Form 3160-5 (August 2007)

Whirling Wind 11 Fed Com 702H 30-025-42934

EOG Resources, Inc Surface Location: Sec. 11, T. 26S, R. 33E Conditions of Approval

See below for the conditions of approval for the multi-bowl wellhead system.

10-3/4" X 7-5/8" X 5-1/2" FBD-100 WELLHEAD SYSTEM QUOTE # - 93482

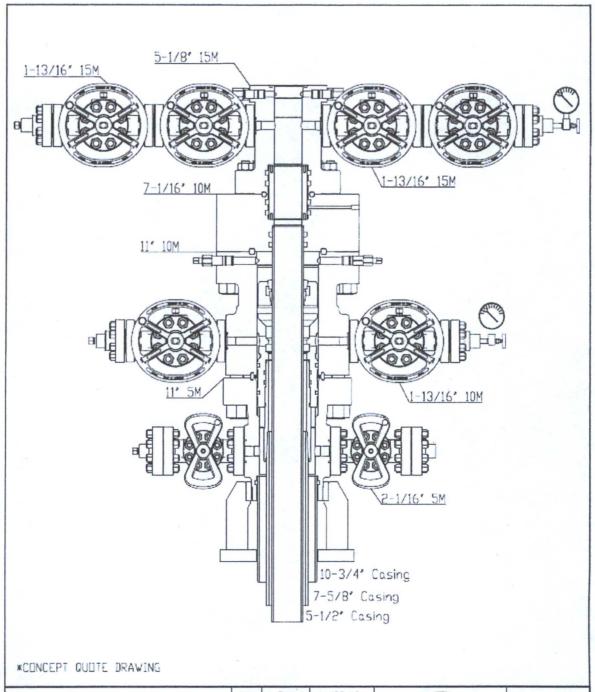
- 2. Operator has proposed a **multi-bowl wellhead assembly**. This assembly (BOPE/BOPE) will be tested when installed on the surface casing. Minimum working pressure of the blowout preventer (BOP) and related equipment (BOPE) required for drilling below the surface casing shoe shall be **5000 (5M)** psi.

- a. Wellhead shall be installed by manufacturer's representatives, submit documentation with subsequent sundry.
 - b. All BOP equipment will be tested utilizing a conventional test plug. Not a cup or J-packer type.

- c. If the welding is performed by a third party, the manufacturer's representative shall monitor the temperature to verify that it does not exceed the maximum temperature of the seal.

- d. Manufacturer representative shall install the test plug for the initial and all BOP testing.
 - e. Prior to running the intermediated casing, the rams will be changed out to accommodate the 7-5/8" casing. After installing the intermediate casing the casing rams will be removed and replaced with variable bore rams.

- Operator has broken a seal on the BOP stack therefore per Onshore Oil and Gas
 Order No. 2 the entire BOP stack shall be tested prior to drilling out the
 intermediated casing.

- a. A solid steel body pack-off will be utilized after running & cementing the intermediate casing. After installation of the pack-off and lower flange will be pressure tested to 5000 psi.

- b. If the cement does not circulate and one inch operations would have been possible with a standard wellhead, the well head shall be cut off, cementing operations performed and another wellhead installed.
